RN SERIES TECHNICAL BULLETIN

ISSUE NO. : RNT-007

SUBJECT: 021-18201-208 Master Loading Sheet

021-18201-003 & 021-18201-100 Master Loading Sheet

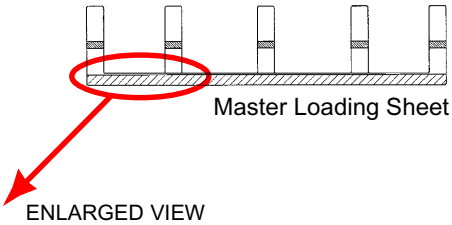
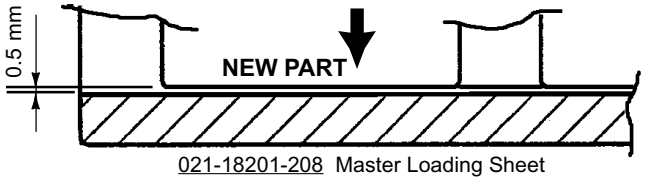
Brief:
The adhesive tape width was narrowed down from 7mm to 6.5mm.

Reason:
The extended portion of the Mylar sheet in some occasions did not rise high enough, when lifted by the opened Clamp Plate, causing the sponges to block the way of the master material coming towards the drum.

Modification:
The 0.5mm margin on the Mylar sheet allows the 5 extended out pieces of the Mylar sheet with the sponges to rise at more acute angle when lifted by the opened Clamp Plate.
This allows the sponges to lift higher, and clears the way for the master material during the master loading on the drum.
